ADVISORY REPORT
FINDINGS, CONCLUSIONS, AND RECOMMENDATIONS

File: **SUB15-00615**

RADKE PRELIMINARY PLAT
A PORTION OF THE SW. 1/4 OF THE NE. 1/4
SECTION 25, TOWNSHIP 26 NORTH, RANGE 4 EAST, W.M.,
CITY OF KIRKLAND, KING COUNTY, WASHINGTON

RADKE SUBDIVISION
KIRKLAND PERMIT NO. SUB15-00615

Figure 1 showing an adjustment to lot 15 which would limit the potential to destabilize the neighbors trees

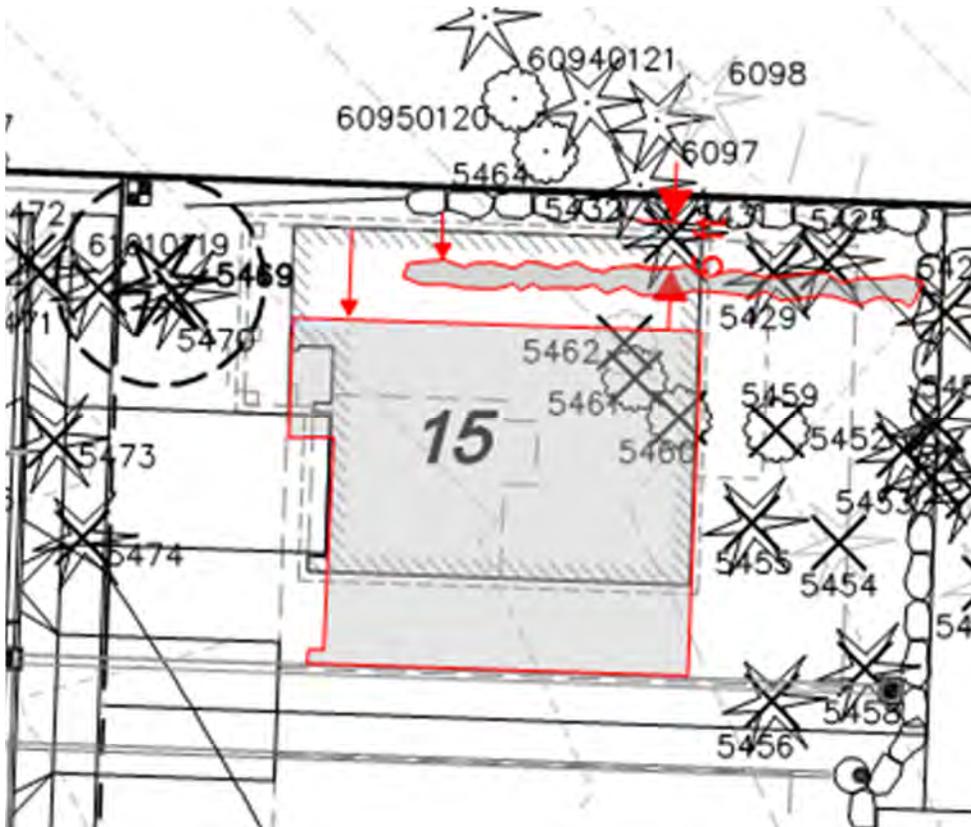
Neighbor’s trees: trees #5464, 6097, 6098, 60940121 and 60950120 are close to a cut wall rockery on the north side of lot 15. It would be good to pull this rockery southward approximately 5’ to provide a root zone for the neighbor’s healthy trees. See figure 1 below.

- 4) The proposed rockery on Lot 15 should be moved 5 feet to the south to reduce impact to the neighboring trees to the north and minimize potential hazards to life or property. If alternative protection measures for these trees are approved by the Planning Official, then the rockery should be allowed to remain as shown in the plan.
